FILVIA Report

Lyrenacarriga WF

Document Title: **FI LVIA Report**

1. RFI – LYRENACARRIGA LVIA INPUT

Figure 1-1 Local Community Photomontage Locations

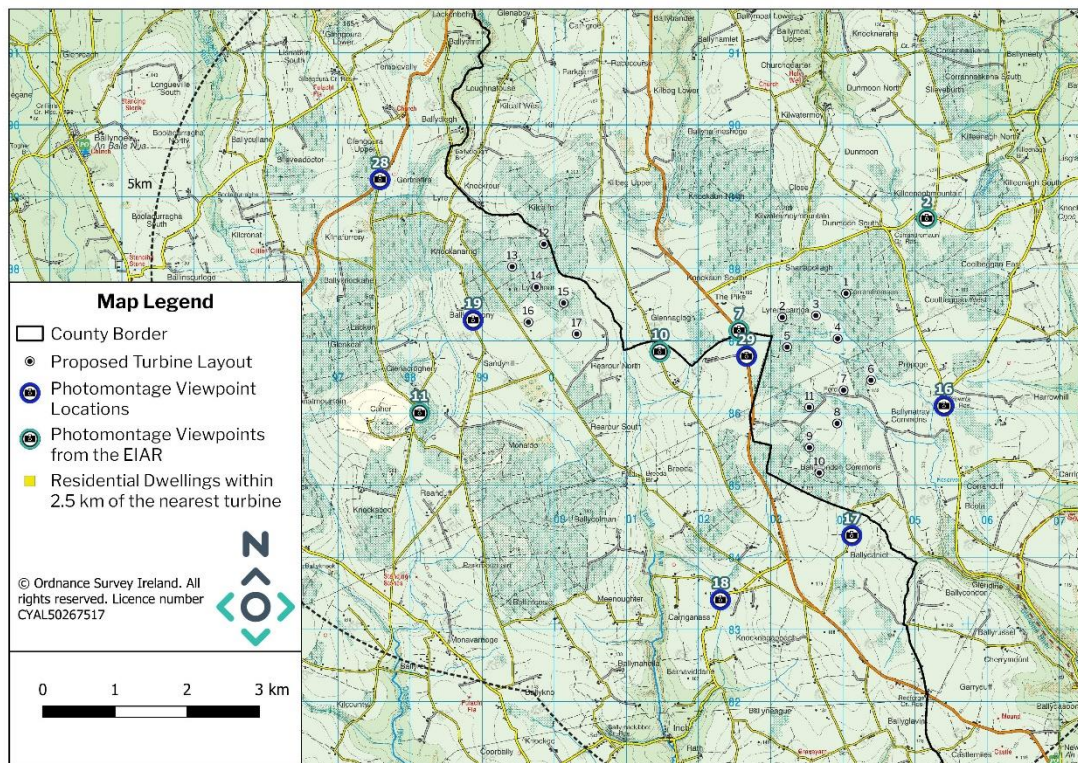
“A) You are requested to provide a number of additional photomontages from viewpoints which represent the local community and from a location to the east of the development which represents the impact on the wider landscape along the Blackwater River particularly in the vicinity of structures of national heritage importance. A photomontage to the south of Tallow along the R627 should also be provided. A thorough viewpoint assessment of the additional viewpoints is also required.”

In relation to “*the local community*” a number of additional photomontages were captured which are comprehensively assessed in full in Appendix 1 which accompanies this report. The locations of these

are shown on Figure 1-1 below, and the photomontages themselves can be seen in Volume 2 – Photomontage Booklet. The following section should be read in conjunction with the Photomontage Booklet and Appendix 1.

There are now a total of 11 photomontages (between the original EIAR and the additional photomontages included in this response to a request for further information) representing the visual effects of the Proposed Development from locations representing the local community. These show representative views of the Proposed Development from multiple orientations and perspectives. As these photomontages are assessed in full in the accompanying appendix (Appendix 1) containing the viewpoint assessment tables, the following section discusses residential visual amenity in a general sense. It is noted however, that there are no Significant residual visual effects deemed to arise in relation to residential receptors as a result of the Proposed Development.

Figure 1-12 35km Zone of Theoretical Visibility

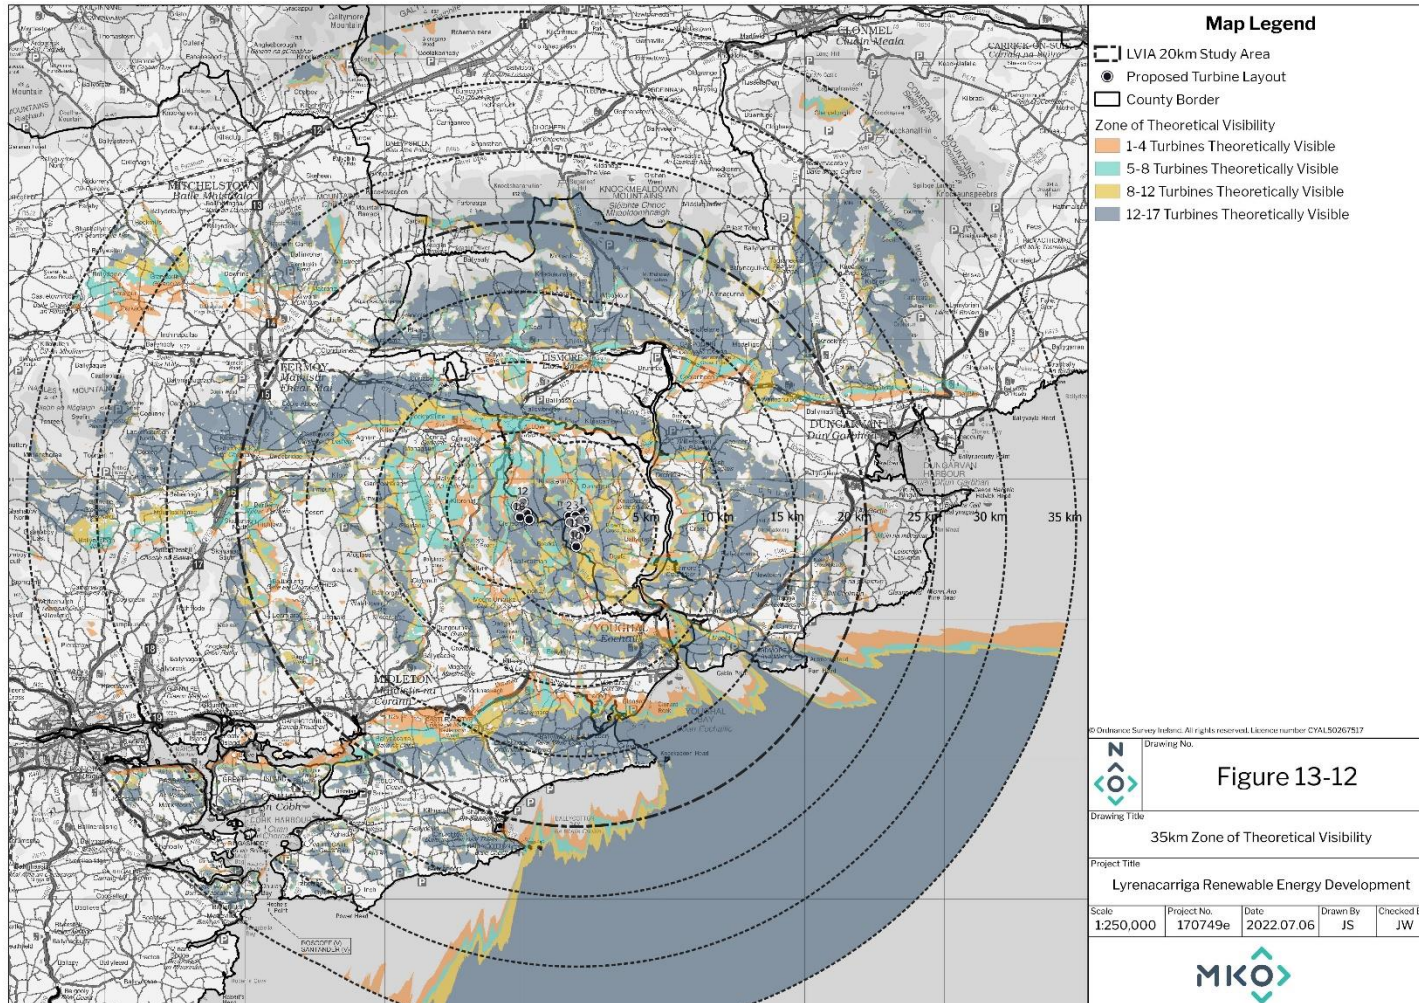
“The Planning Authority would also draw the Bords attention to the Zone of Theoretical Visibility, in particular the extend of the area to the north of the site from which 13-17 turbines will be visible. Based on topographical conditions, the ZTV could extend beyond the 20 km radius particularly in the areas to the north and north west, towards Mitchelstown.”

In order to comprehensively address the Council’s submission, a 35km Zone of Theoretical Visibility (ZTV) was run and is shown on Figure 1 below. However, it is necessary to first make a number of points in relation to the necessity (or lack thereof) of running a ZTV at this distance in order to assess any likely significant landscape and visual effects of the Proposed Development. Firstly, within the Wind Energy Development Guidelines (2006, DoEHLG) and the Draft Revised Wind Energy Development Guidelines (2019, DoHPLG) which are referenced numerous times by Cork County Council in their submission, it is stated that

In any case, a 35 km ZTV was produced and is shown on Figure 1 below. It can be seen clearly that the theoretical visibility in Mitchelstown, noted by Cork County Council, is not existent, i.e., there is no theoretical visibility of the Proposed Development in Mitchelstown. In addition, it can also be seen that the “*areas to the north*” outside of 20km (as highlighted by the County Council as having potential theoretical visibility) do not in fact have substantial areas of theoretical visibility beyond the 20km LVIA Study Area, as visibility is primarily constrained by the topography of the Knockmealdown Mountains.

Overall, it is submitted that discussion here has shown that, firstly, the Council’s concerns regarding the ZTV have already been addressed within Chapter 12 of the EIAR, which follows the guidance quoted by the Council themselves, and that any potential significant landscape and visual effects have been comprehensively assessed (including through the use of a Photomontage – Viewpoint 1).

Figure 1-13 Viewpoint 45 Location

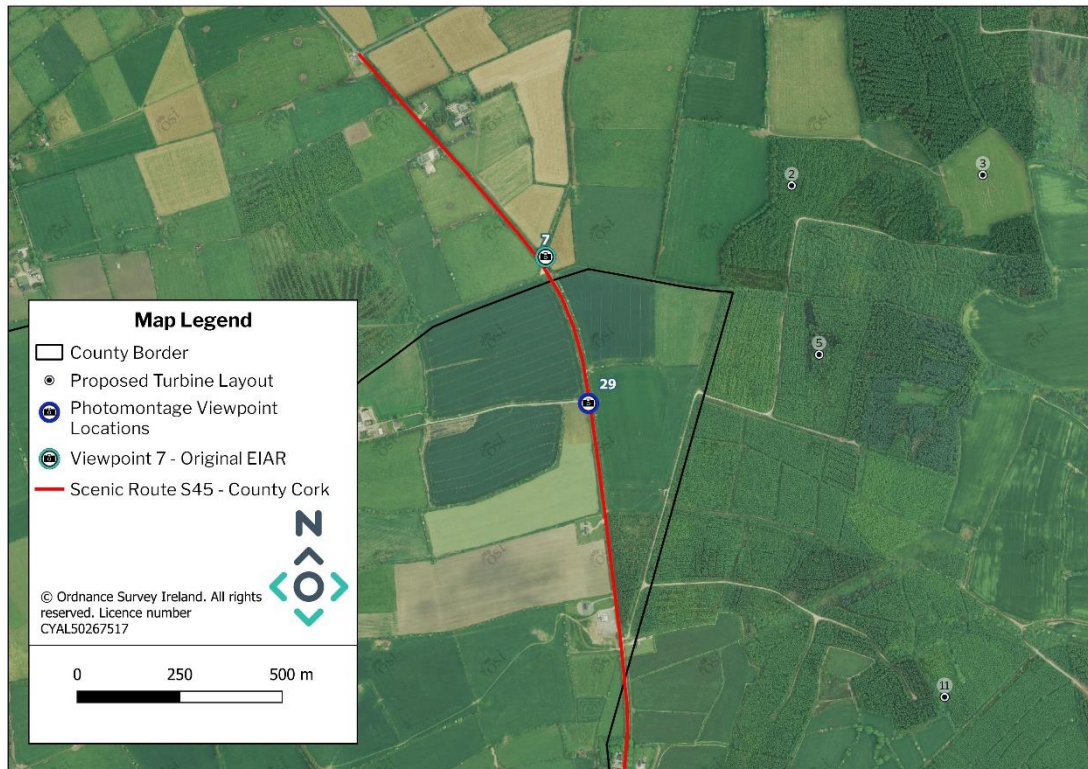
“The applicant has provided a detailed consideration of the impacts along this route, Viewpoints 7a and 7b are taken from this route. In considering this view, the applicant has assigned the visual sensitivity of the receptor to low. In appendix 12-2, when describing this viewpoint, the applicant has not described it as a scenic route. Notwithstanding the specific regard given to S45 in Section 12.8.3.3.4 of the EIAR, the Planning Authority has serious reservations about the visual sensitivity afforded to the receptor at viewpoint 7. When considered from this viewpoint, 13 of the 17 turbines are visible.”

In any case, for the avoidance of doubt, the concerns of the County Council highlighted here related to the sensitivity of this viewpoint are addressed secondly through the capture of a photomontage at a location further south along the road, where the sensitivity is rated ‘Medium’ as explained in the text quoted below. Viewpoint 29 (shown on Figure 1-13 below) is located further south along the road, within County Cork. Viewpoint 29 is assessed in full detail in Appendix 1, however, it is noted that the sensitivity of the Viewpoint is deemed to be Medium in that location, as explained in the following quote from Appendix 1:

Essentially, while this viewpoint is located along a designated scenic route, in the professional judgment of the author, the scenic value attributable to this section of road is extremely limited. The view in either direction is a short-to-medium range view over agricultural fields towards tracts of commercial monoculture forestry, offering little by way of valuable scenic amenity. In fact, similar views (and commonly those of a higher scenic quality) are generally available throughout this part of the LVIA Study Area in close proximity to the Proposed Development.

In the case of this additional photomontage and visual assessment conducted, residual visual effects were deemed to be ‘Moderate’ and once again it is noted that Significant visual effects will not arise. The addition of the Proposed Development into views from this stretch of road will not significantly impact any key fundamental scenic sensitivities related to this stretch of road (as these are limited in any case). It is also emphasised that this stretch of road was considered in substantial detail in Section 12.8.3.3.4 of the EIAR with multiple rounds of imagery, overlaid wireframes, and now fully rendered Photomontages, as well as text-based discussion and explanation of likely visibility. It is submitted that due to the extensive amount of attention paid to this stretch of regional road that it is clear that no Significant visual effects will arise.

Figure 1-14 Aerial view of the section of the L7806 driven

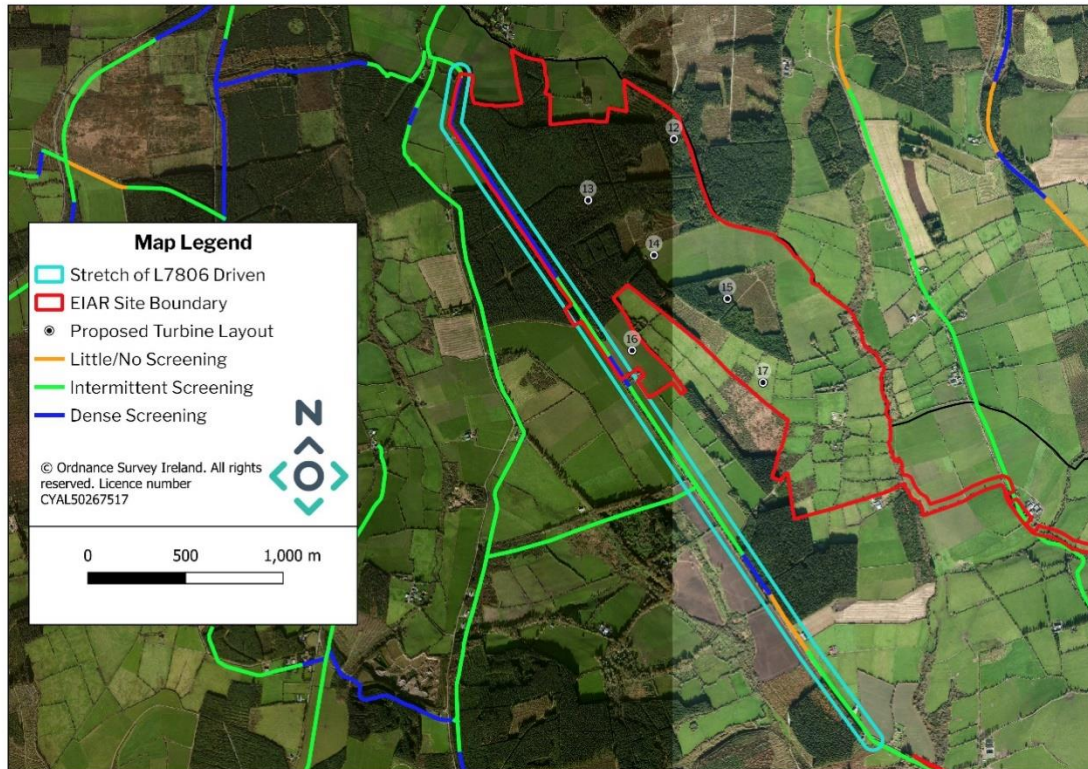
“Of particular concern is the lack of any visual assessment from the L7806, which runs immediately west of the western cluster of 6 turbines. Turbine 16 is c. 125 metres from this road in an open field. The visual impact of the proposed turbines will need to be further considered along this stretch of local road, particular at the points immediately south of the proposed access and a point 500 metres north of the access.”

The following is a discussion of the L7806 local road detailing its conditions and the potential views towards the western cluster (the cluster located closer to this road) of turbines from locations along this road. An aerial view of this road is shown below in Figure 1-14 below, which shows the length of the stretch of road under discussion here, and the level of roadside screening as recorded during the LVIA conducted as part of the original EIAR (detailed in full in Section 12.8.3.3.3).

During a site visit conducted on 17th June 2022 the portion of the road described in the above quoted text was driven from the north-west to the south-east, alongside the border with the western half of the Proposed Development Site. In general, visibility in the direction of the Proposed Development is heavily screened by the mature coniferous plantation forestry that comprises much of the landcover of the site, as seen in Plate 1-6 below (Proposed Development located to the left of the image).

Figure 1-15 Residential Visual Amenity Set-Back Distance*

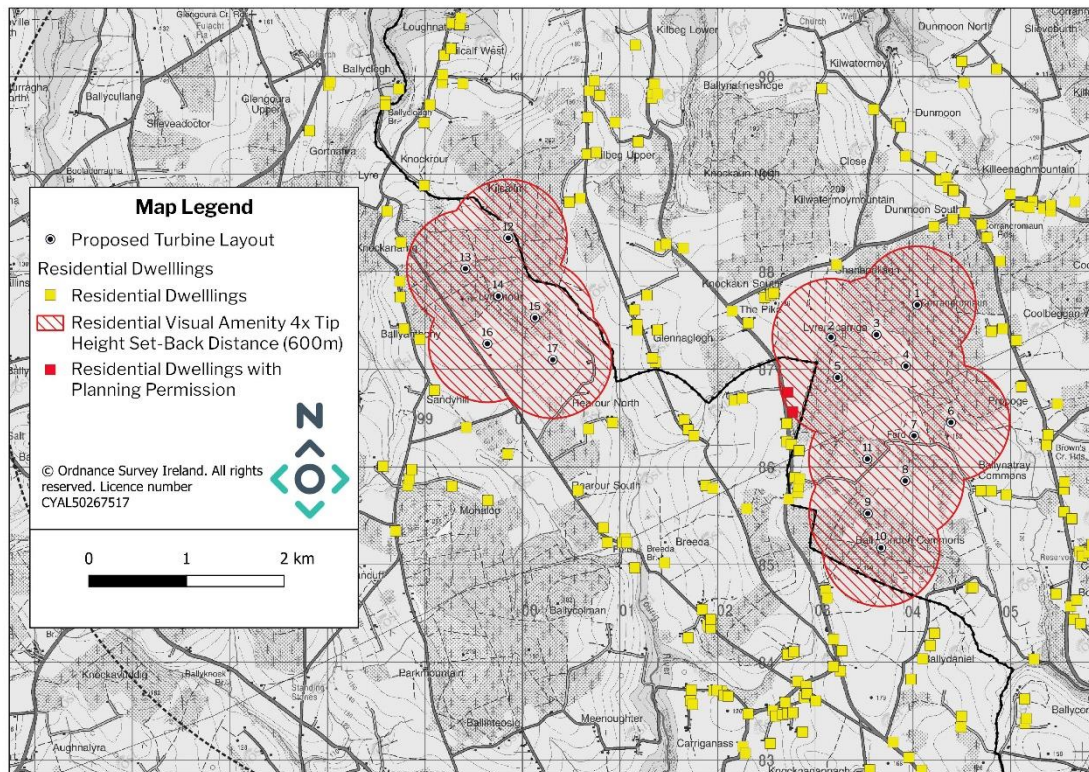
The applicant has not considered the visual impact of the turbines on those residential properties either to the west of the western clusters or those properties to the south of the eastern cluster. This is a concern particularly in light of Objective ED 3-5 of the County Development Plan which requires the consideration of impacts on residential amenity in respect of visual impact.”

Potential for impact on sensitive residential receptors has been kept to the fore throughout the iterative design process adopted for the Proposed Development and has been considered in full within the EIAR. The Draft Revised Wind Energy Development Guidelines (2019, DoHPLG) contain Specific Planning Policy Requirements (SPPRs). Of specific relevance here in relation to appropriate setback distances is SPPR 2 which states:

It is submitted that in relation to residential **visual** amenity, which is under consideration *“for the purposes of the visual assessment”*, a set-back distance of *“4 times the tip height of the relevant wind turbine”* is required in relation to residential visual amenity. As illustrated in Figure 1-15 below, the Proposed Development is compliant with the 4 times tip height set-back distance (noted above - SPPR 2) prescribed by the Draft Revised Wind Energy Development Guidelines (2019, DoHPLG).

Visual effects on residential receptors are considered outside of this requirement, as discussed in some detail within Section 12.8.3.5 of the EIAR (which discusses the visual effects on residential properties between the two clusters) as well through the use of various other photomontage viewpoints throughout the LVIA study area and discussion of visual effects within Sections 12.8.3.3.3 of the EIAR.

Figure 1-16 Residential Receptors highlighted by Waterford County Council

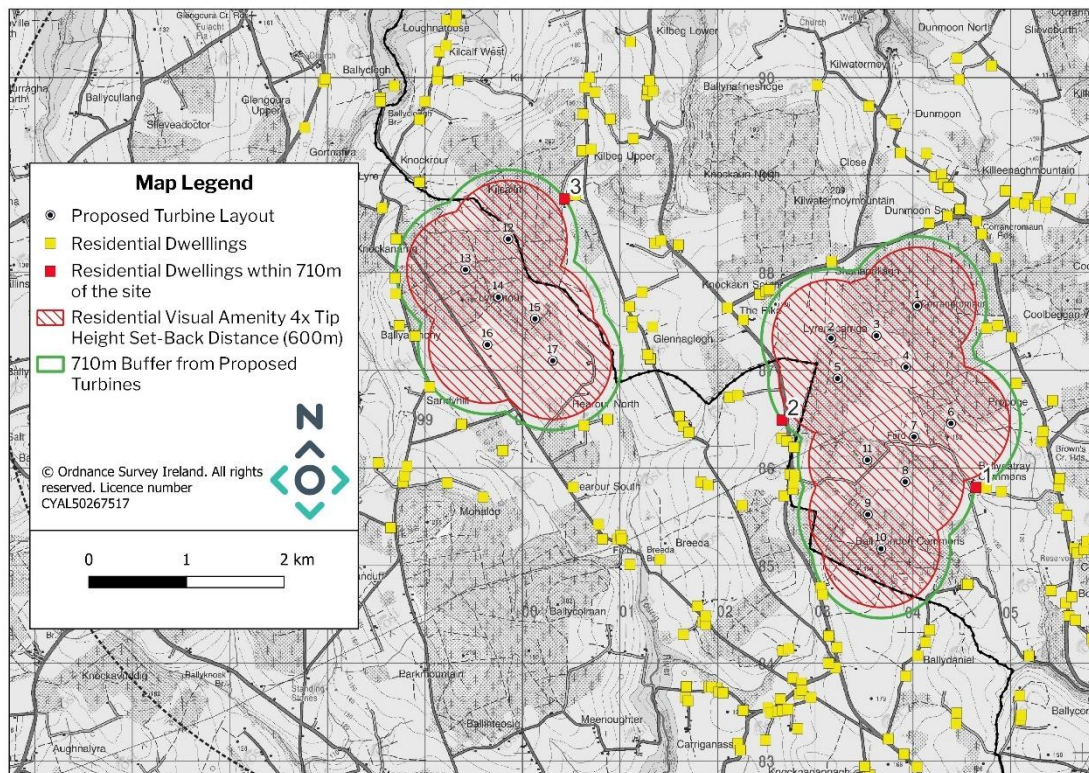
Waterford County Council has made a number of comments relating to the landscape and visual impact of the Proposed Development. A number of these comments are generic commentary relating to the 15 (no.) Photomontages presented in the original EIAR. It is reiterated in this regard that these Photomontages were assessed in substantial detail in Appendix 12-3 of the EIAR and no Significant residual visual effects were deemed to arise. It is submitted that none of the comments made by Waterford County Council in relation to these viewpoints suggest or imply that Significant visual effects arise.

The residential receptors noted above are shown on Figure 1-16 below. In relation to the residential dwelling marked a No. 1 on the map below, this is owned by a participating landowner in the project.

In relation to the residential dwelling marked as No. 3 on the map below, it is noted that bordering this receptor to the west is a large tract of commercial plantation forestry which provides substantial screening of views in the direction of the nearest turbine (T12). As a result, there are likely to be limited views in the direction of the Proposed Development (western cluster).
